Wisconsin Department of Transportation

Proposal #06: 5310-02-75, WISC 2022380
Spring Green - Madison
Pleasant View Road Intersection
USH 14
Dane County

This is Addendum No. 02, which provides for the following:

ADDENDUM NO. 02
5310-02-75/5992-11-01/5992-11-02
September 8, 2022

Addendum No. 02
ID 5992-11-01
Revised Sheet 7
September 8, 2022

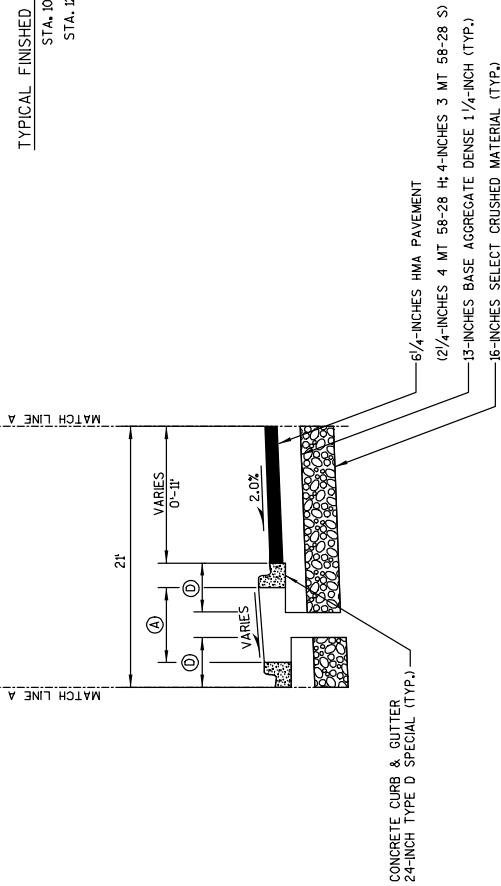
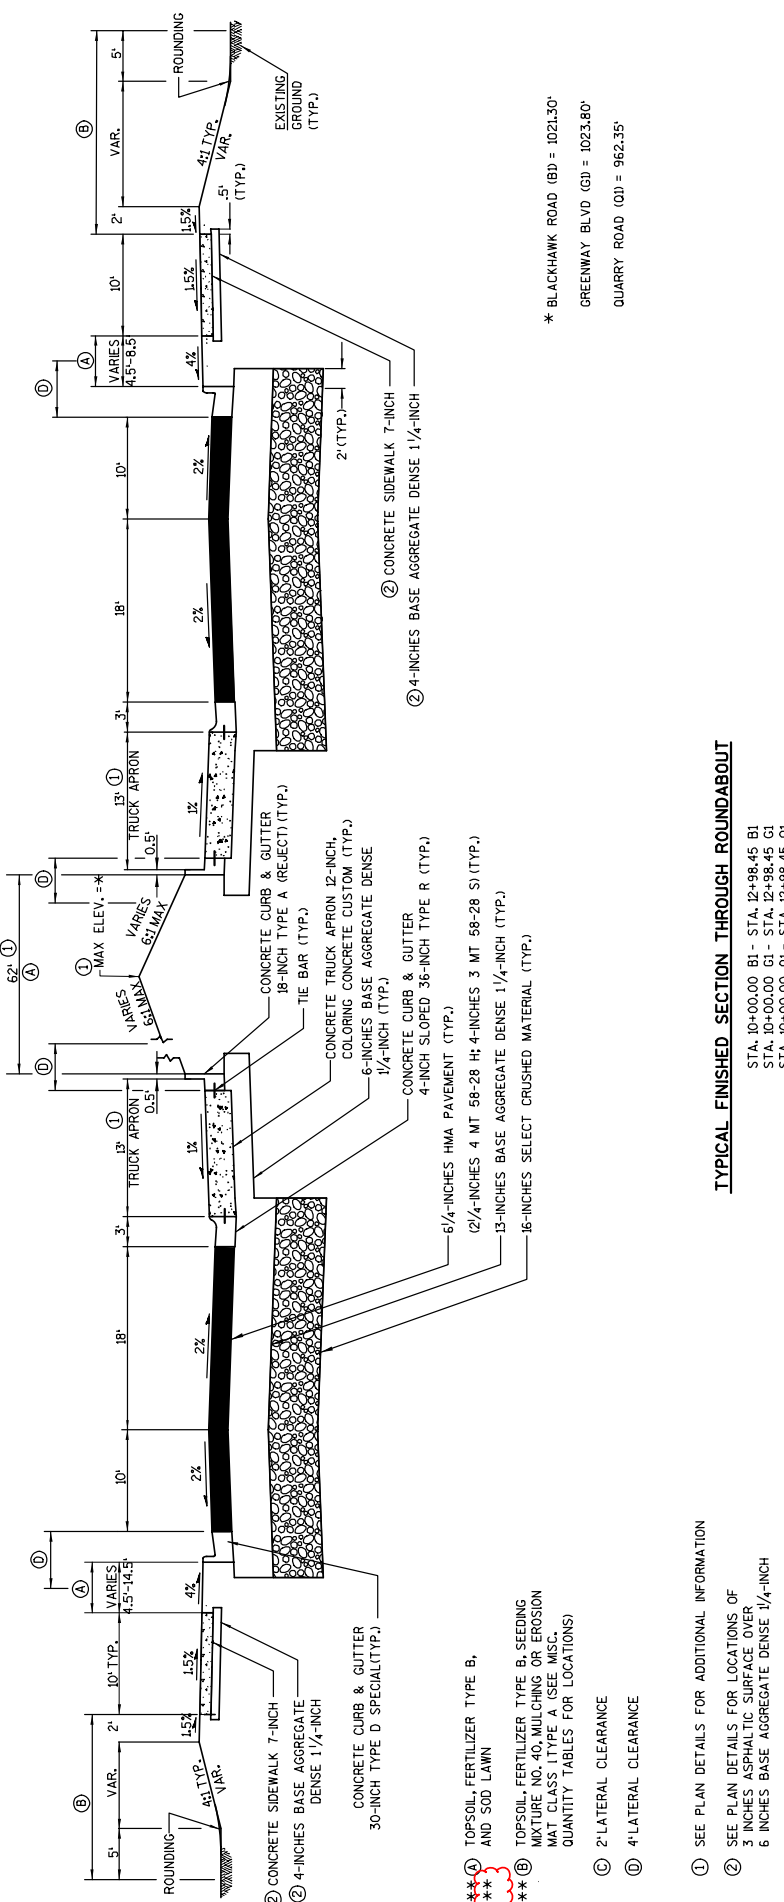
Revised Plan Sheets	
Plan Sheet	Plan Sheet Title (brief description of changes to sheet)
7	Typical Finished Sections (Added note for Topsoil Plant Mix and Shortgrass Prairie Seed Mix)
8	Typical Finished Sections (Added note for Topsoil Plant Mix and Shortgrass Prairie Seed Mix)
123	Erosion Control - Pleasant View Road (Revised median hatch to mulching)
124	Erosion Control - Pleasant View Road (Revised median hatch to mulching)
125	Erosion Control - Pleasant View Road (Revised median hatch to mulching)
126	Erosion Control - Pleasant View Road (Revised median hatch to mulching)
508	Miscellaneous Quantities (Revised Finishing table to add Topsoil Plant Mix and Shortgrass Prairie Seed Mix)
509	Miscellaneous Quantities (Revised Finishing table to add Topsoil Plant Mix and Shortgrass Prairie Seed Mix)
757	B-13-892 Cross Section, General Notes & Details (Removed Arch Façade Plate)
764	B-13-892 Arch and Protective Screening Details (Removed Arch Façade Plate)

*** TOPSOIL PLANT MIX, FERTILIZER TYPE B, SHORTGRASS PRAIRIE SEED MIX, AND MULCHING STA. 108+32.00 TO STA. 127+95.24

Addendum No. 02
 ID 5992-11-01
 Revised Sheet 8
 September 8, 2022

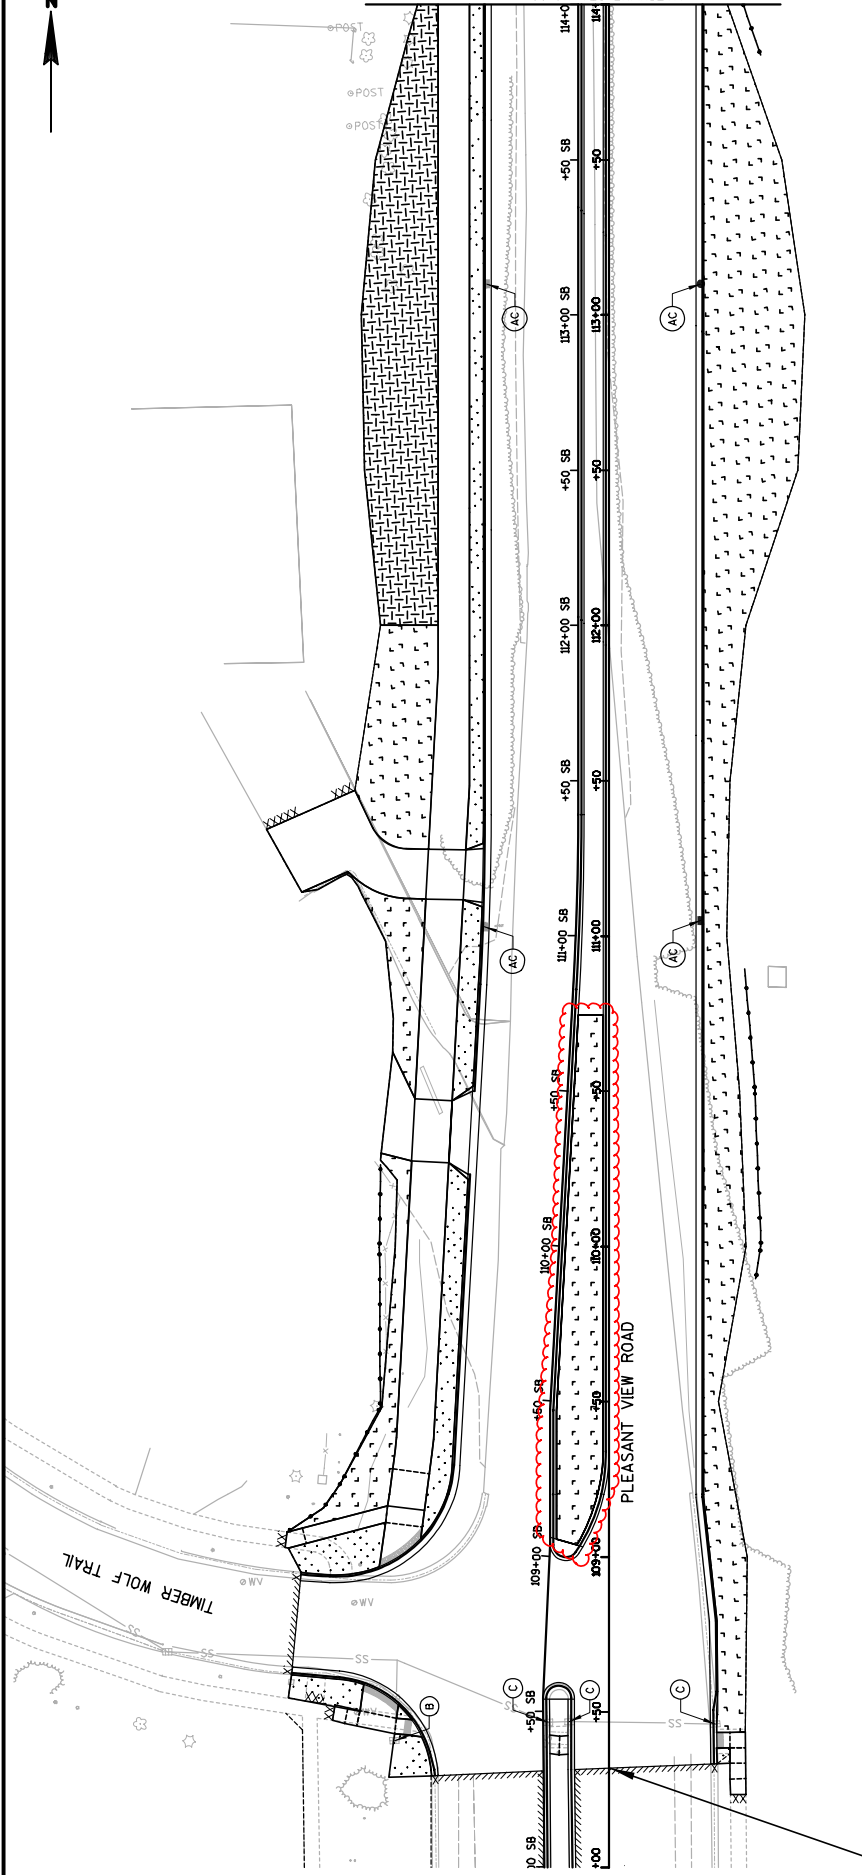
*** ④ TOPSOIL, FERTILIZER TYPE B, AND SOIL LAWN
 *** ⑤ TOPSOIL, FERTILIZER TYPE B, SEEDING MIXTURE NO. 40, MULCHING OR EROSION MAT CLASS I TYPE A (SEE MISC. QUANTITY TABLES FOR LOCATIONS)
 *** TOPSOIL PLANT MIX, FERTILIZER TYPE B, SHORTGRASS PRAIRIE SEED MIX, AND MULCHING
 STA. 10+00.00 BITO STA. 12+98.45 BI
 BLACKHAWK ROAD RAB CENTRAL ISLAND
